PUBLIC FEEDBACK ON DRAFT CHINATOWN ZONING

The City of Boston's Planning Department released the Draft Chinatown Zoning Amendment, Draft Zoning Map, and Draft Design Guidelines on November 19, 2024; the public comment period was open through February 5, 2025. Throughout the public comment period, Planning Department Staff solicited feedback from a variety of sources, including a survey, emails, comment letters, and petitions.

Figure 1 Former Institutional Parcels in Longwood Since 2010

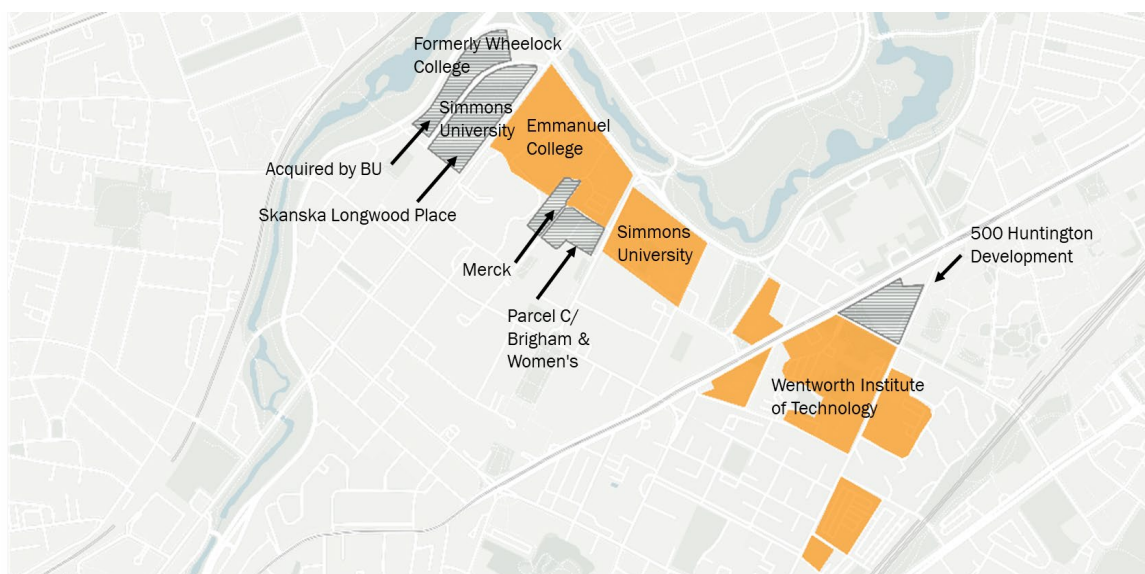
- **Longwood’s “De-accessioning” has been Managed through IMPs and has Added Compatible Uses.** Land that has been removed from IMPs in Longwood has typically moved from educational uses to uses in support of Longwood’s research, life sciences and clinical needs. A map is provided below. This is projected to continue in the same fashion, as the Simmons Residential Campus is redeveloped with office, life-science and residential uses.

This underscores the importance of Research Laboratory being an allowed use in any re-zoning of the Longwood Area.
